Access Compliance Report

Public Rights-of-Way

Intersection ID: 30010	Main Street: BACKWATER_DR	Cross Street: SMOOTHSTONE_LN	Location: SW
ADA ID: 2D941923B0FB	Ramp Type: PerpDiag	Initial Pass/Fail: Fail	Overall Compliance: No
		Severity Score: 10

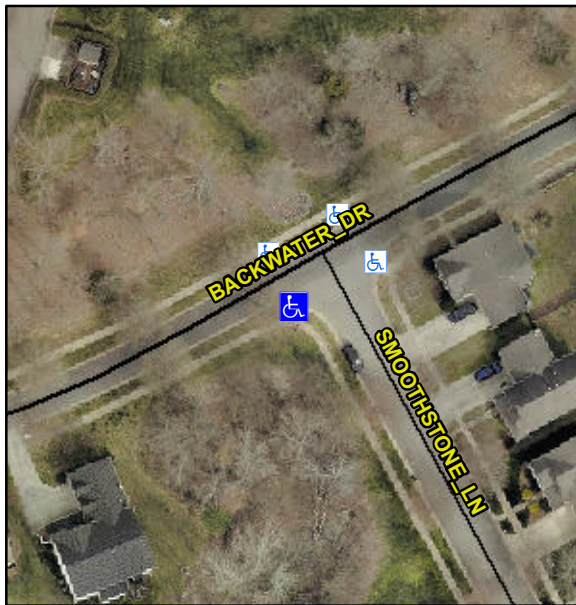
Not Found, R304.5.1, R304.5.3

Compliance	Description	Data	Compliance	Description	Data
N/A	Ramp Length (in)	69.0	Yes	Ramp Slope (%)	5.7
No	Ramp Width (in)	47.4	No	Ramp XSlope (%)	3.5
N/A	Flare Type LT	N/A	N/A	Flare Type RT	N/A
N/A	Flare Slope LT (%)	N/A	N/A	Flare Slope RT (%)	N/A
N/A	Flare Traversable LT?	N/A	N/A	Flare Traversable RT?	N/A
N/A	Landing Length (in)	N/A	N/A	DWS Provided?	N/A
N/A	Landing Width (in)	N/A	N/A	DWS Contrast?	N/A
N/A	Landing Slope (%)	N/A	N/A	DWS Length (in)	N/A
N/A	Landing X Slope (%)	N/A	N/A	DWS Full Width?	N/A
N/A	Landing Curb? (Y/N)	N/A	N/A	DWS Offset (in)	N/A
N/A	Shared Landing?	N/A			
N/A	Gutter Ponding?	N/A	N/A	Gutter Slope (%)	N/A
N/A	Gutter Lip Ht (in)	N/A	N/A	Gutter X Slope (%)	N/A
N/A	Painted X Walk1?	No	N/A	Painted X Walk2?	No
	X Walk 1 Direction	To E		X Walk 2 Direction	To N
N/A	X Walk 1 Width (in)	N/A	N/A	X Walk 2 Width (in)	N/A
	X Walk 1 Slope (%)	5.5		X Walk 2 Slope (%)	4.6
	X Walk 1 X Slope (%)	4.4		X Walk 2 X Slope (%)	4.5

Remove & Replace Curb Ramp With Two New Directional Ramps or Equivalent.
